Grandview Commons Town Center Amendment Request

Addendum Packet #1

**Re: Grandview Commons Town Center
PUD:GDP/Sprecher Neighborhood/Comprehensive Plan
Addendum Packet #1**

Grandview Commons
 Town Center/Doric Lodge
 Revised General Development Plan

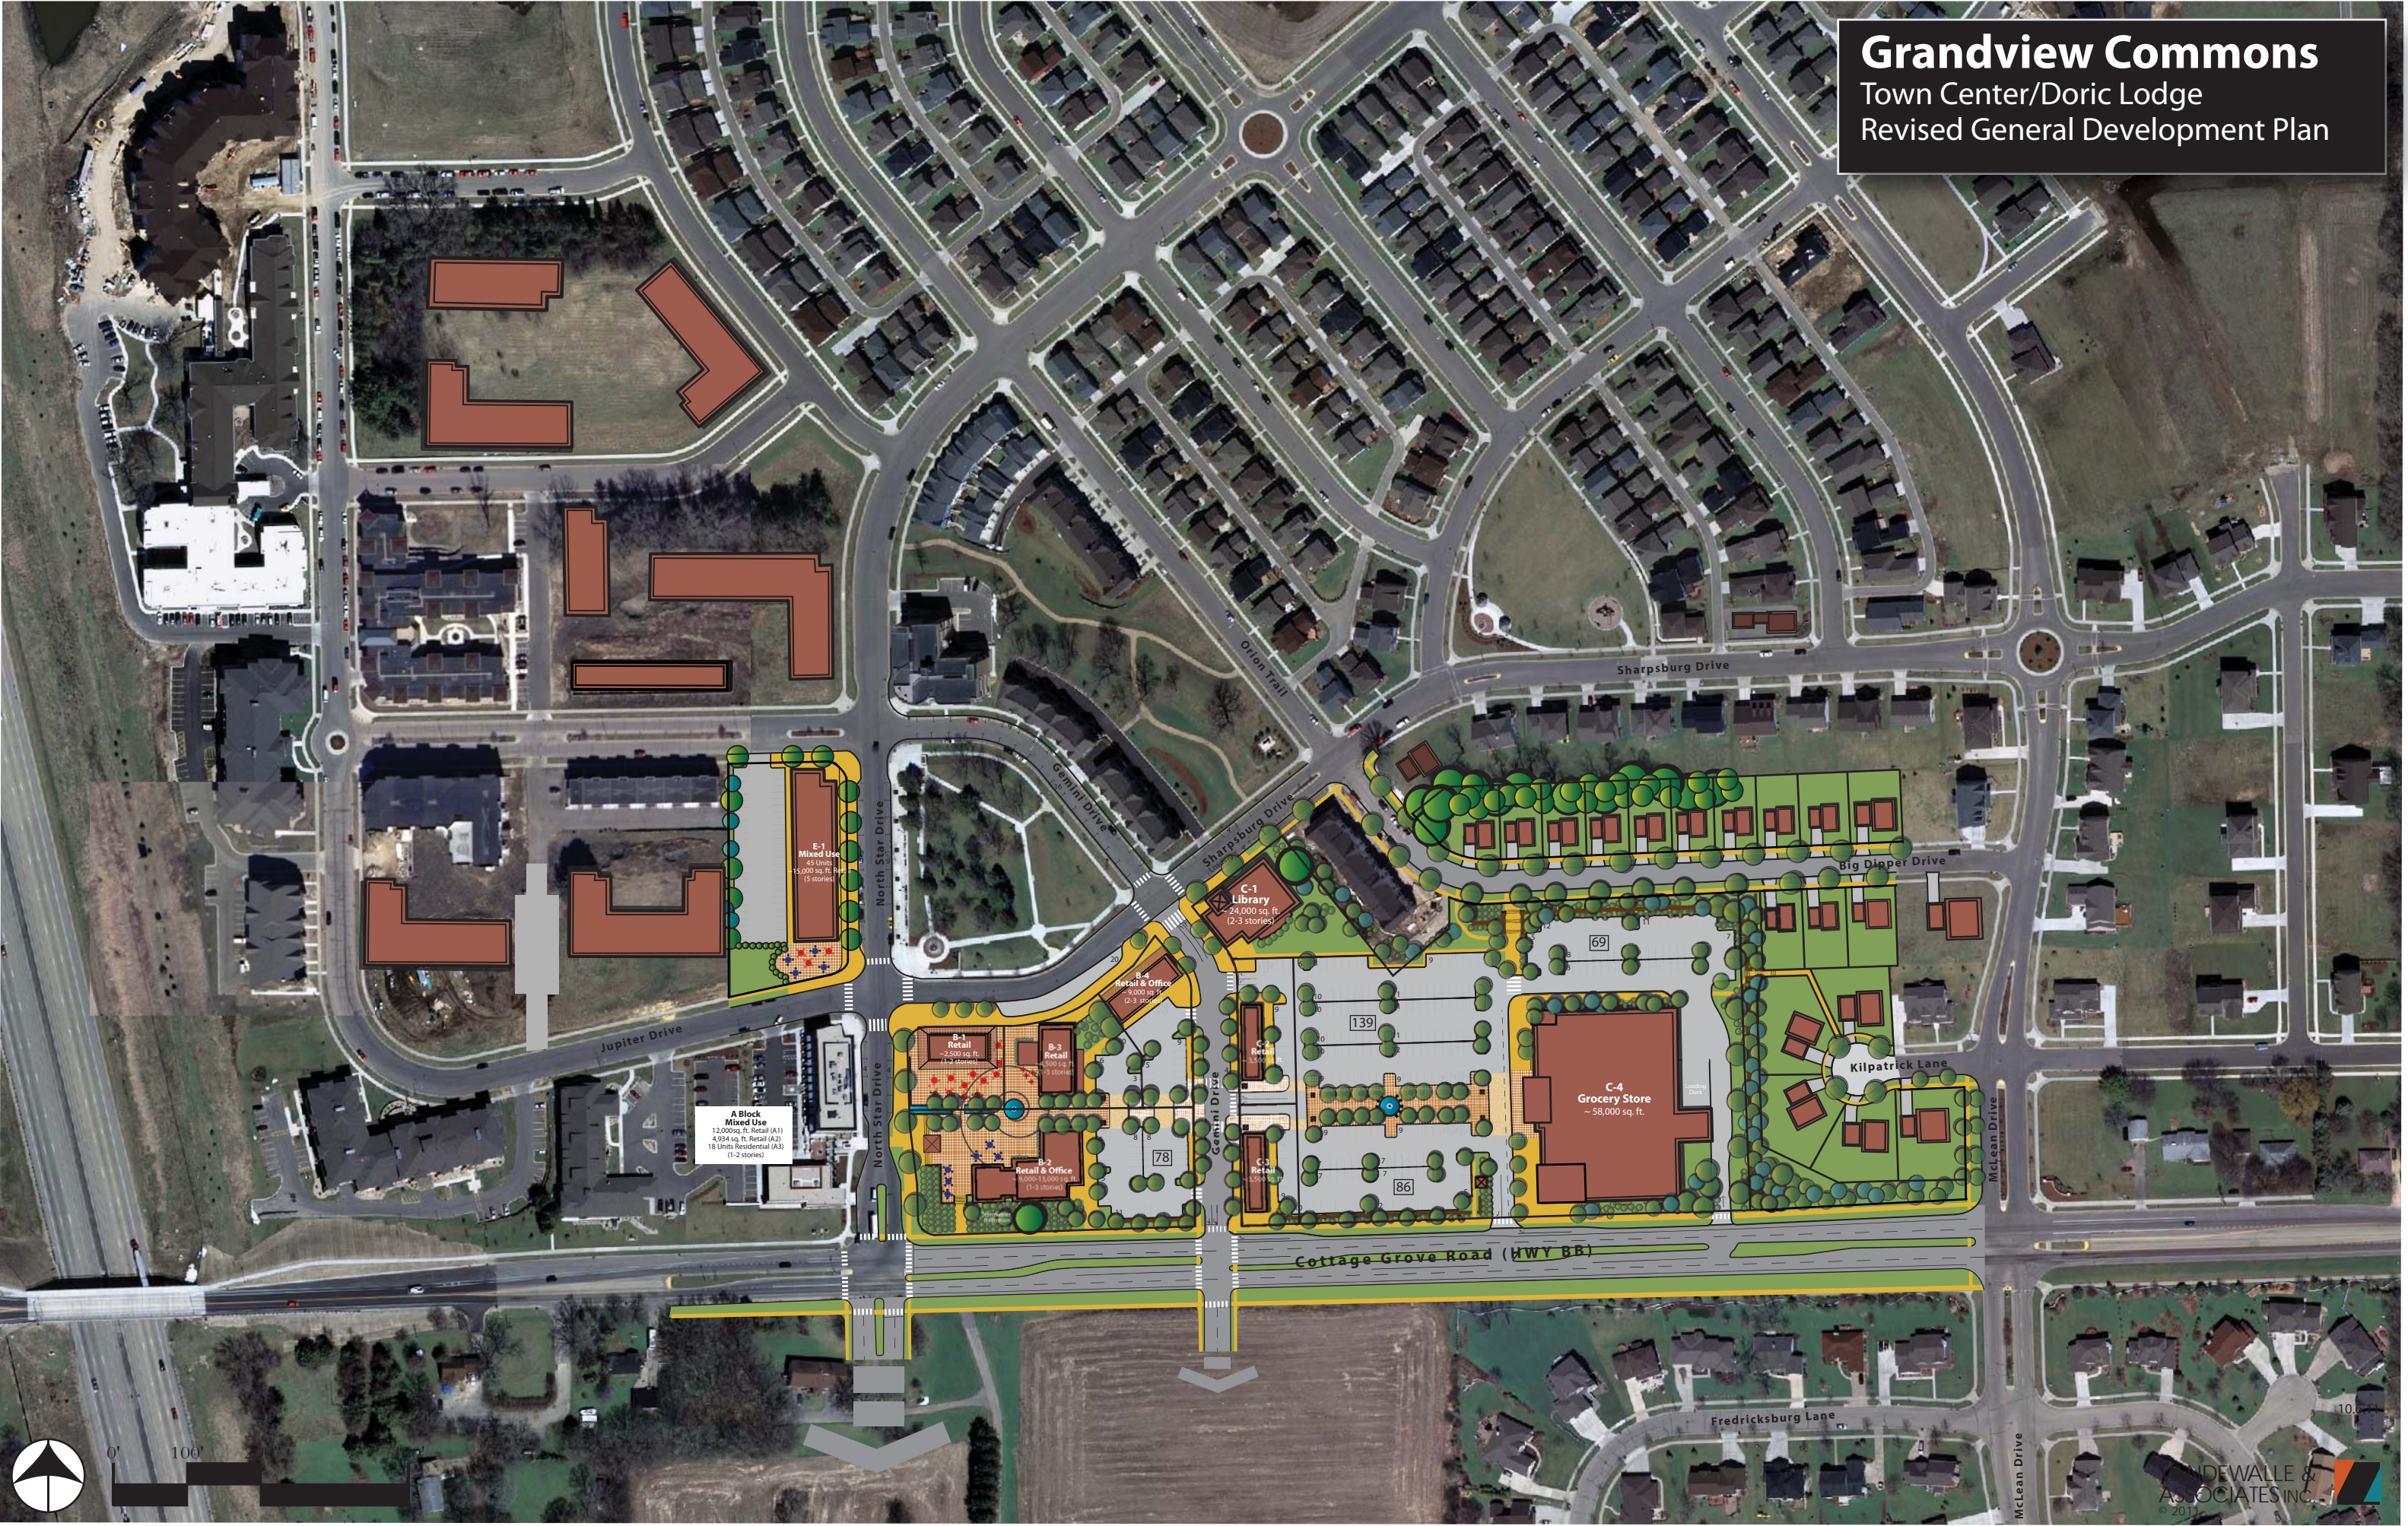
- 1.) *Central Walkway Enhancement*
The C block shared parking area has been revised to create a stronger pedestrian connection from Gemini Drive to the front of the Grocery Store. This pedestrian plaza will offer a unique connection from the urban plaza to the front of the store and will further divide the parking field into distinct segments. Initial concepts for this space include raised planter beds, vertical gateway elements, an arcade of trees, and a central landscape element echoing the feature in the urban plaza.

- 2.) *Grocery Store Entrance*
The Cottage Grove Road entrance for the grocery store has been revised, in consultation with Traffic Engineering, to create an additional in-bound lane/drop off lane. This lane, coupled with a dedicated right turn lane, and the removal of out-bound left turns helps reduce conflicts and improve the overall function of the front of the store.

- 3.) *Gemini Drive Street/Entrance*
The Gemini Drive entrance has been reconfigured to allow for a street intersection with full turning movements and the ability to extend it south of Cottage Grove Road when the property south of the road is developed.

- 4.) *Gemini Drive Street*
Gemini Drive, per Traffic Engineering's request, is identified for dedication as a public street through the site.
- 5.) *Northern Sidewalk*
Additional pedestrian routing through the site has been created through the placement of an east-west sidewalk connection along the entire northern edge of the parking field offering a secondary connection from the library site to the grocery store.

- 6.) *Big Dipper Drive Access Ramp*
Bicycle connections and handicapped accessibility from the site to Big Dipper Drive have been enhanced with the placement of a ramp connection north of the grocery store.

- 7.) *Kilpatrick Court Pedestrian Connection*
Pedestrian connectivity has been enhanced through the creation of a walkway connection from the north side of the grocery store to the end of Kilpatrick Court. This connection will have to include steps due to the grade, but will offer an additional route to the east of the store.
